**U.S. ENVIRONMENTAL PROTECTION AGENCY, REGION 8
NATIONAL POLLUTANT DISCHARGE ELIMINATION SYSTEM
STATEMENT OF BASIS**

FACILITY NAME AND ADDRESS: Cheyenne Mountain Space Force
Station

PERMIT NUMBER: CO-0034762

PUBLIC NOTICE AND RESPONSE TO COMMENTS

Figure 1. Aerial View of Facility with External Outfall Locations a/, b/

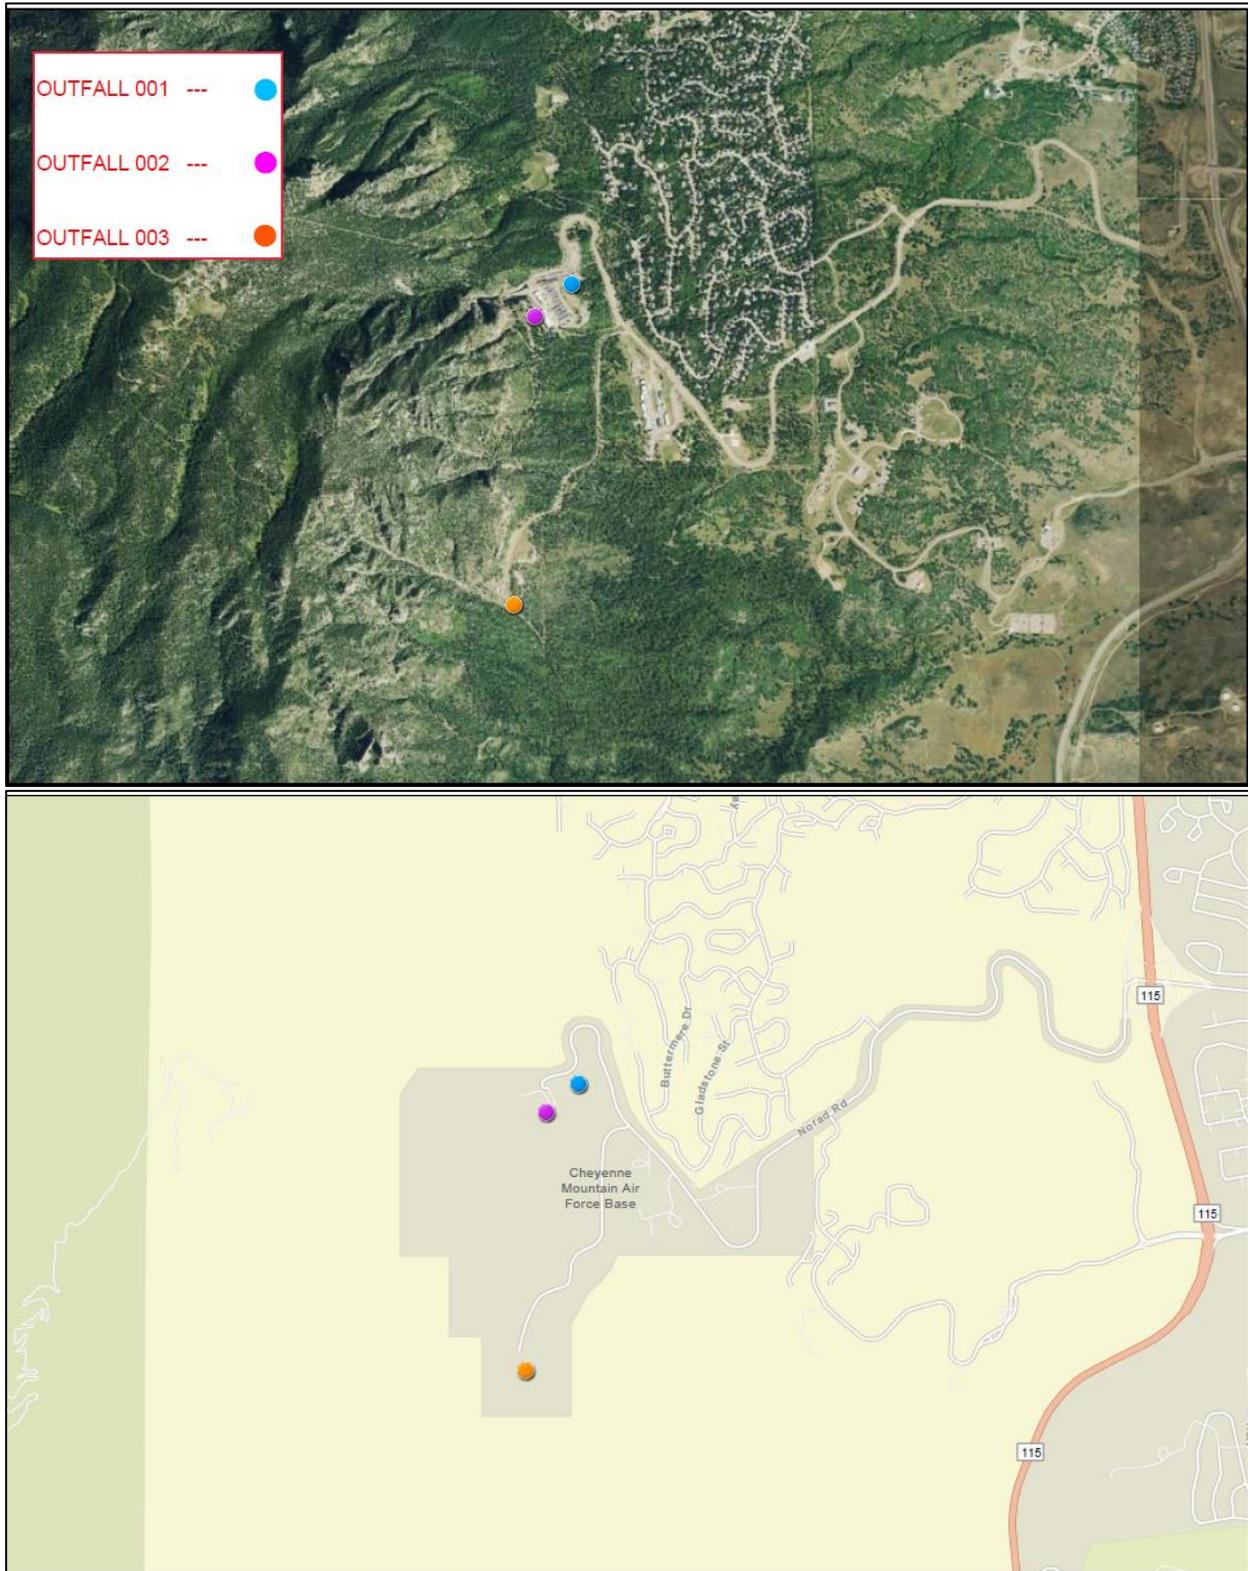
Comment #3:

Second, the description of the receiving waters contained in the 2016 SoB indicate that the receiving waters for both the air exhaust stacks and outfall 001 would not meet the current definition of a WOTUS post-*Sackett*. For example, the 2016 SoB stated, “The discharge from Outfall 001 and the potential discharges from Outfalls 002 and 003 *could* go to the unnamed *ephemeral* tributaries of Fountain Creek . . .” 2016 SoB, Receiving Waters, pg. 9 (emphasis added). The 2016 SoB further noted, “the discharge from Outfall 001 and the potential discharge from Outfall 002 go to an unnamed *ephemeral* tributary that flows to the east for approximately two miles . . . and onto the Fort Carson Military Reservation (FCMR). On the FCMR, the unnamed tributary combines with other unnamed streams and drainage ways to form one stream that flows to the southeast into Fountain Creek ” *Id.* (emphasis added). The 2016 SoB then stated, “[b]ased on a map, this author estimates it is *at least 10 stream miles* from the point of discharge from Outfall 001 to the confluence of the unnamed tributary with Fountain Creek.” *Id.* (emphasis added).

Comment No. 3 requests the removal of Outfalls 002 and 003. As described in the statement of basis, Outfalls 002 and 003 are drain lines located, respectively, at the base of the north and south exhaust stacks. Permit provisions requiring regular inspections have been imposed on these discharge points since the 2005 iteration of the Facility’s NPDES permit. The permit record indicates that no discharges have occurred at these locations over the eighteen-year period that they have been included in the Facility’s permit. For this reason, EPA intends to remove Outfalls 002 and 003 from the final permit, per the request of the Permittee. Once removed from the Permit reissuance, and the Permit becomes effective, no further permit requirements will be imposed on these locations and no future discharges from these points shall be authorized unless NPDES Permit coverage is obtained at a later date.

Comment No. 3 includes commentary on the draft statement of basis's description of the distance between the point of discharge from Outfall 001 and the confluence of the unnamed receiving tributary with Fountain Creek. While this part of Comment No. 3 does not include a permitting request, the EPA will respond to provide clarity. The comment repeatedly references the assertion in the 2016 Statement of Basis that the immediate area of discharge is, "at least ten stream miles" from the receiving water's (the unnamed tributary) confluence with Fountain Creek. However, the State of Colorado's 2024 Stream Segmentation Tool shows that Outfall 001 is located about 0.3 miles from a section of the unnamed tributary for which the State has established water quality standards and designated uses as defined in regulation per Colorado Regulation No. 32 "Classifications and Numeric Standards for Arkansas River Basin." Furthermore, historic flow data reported by the Facility shows an average flow over the last reporting period, 2017 to 2023, of 106,324 gallons per day, with the largest reported flow being 763,147 gallons per day. As such, there appears to be ample evidence to support that discharges from this facility have the potential to reach waters for which the State has established water quality standards with protected uses.
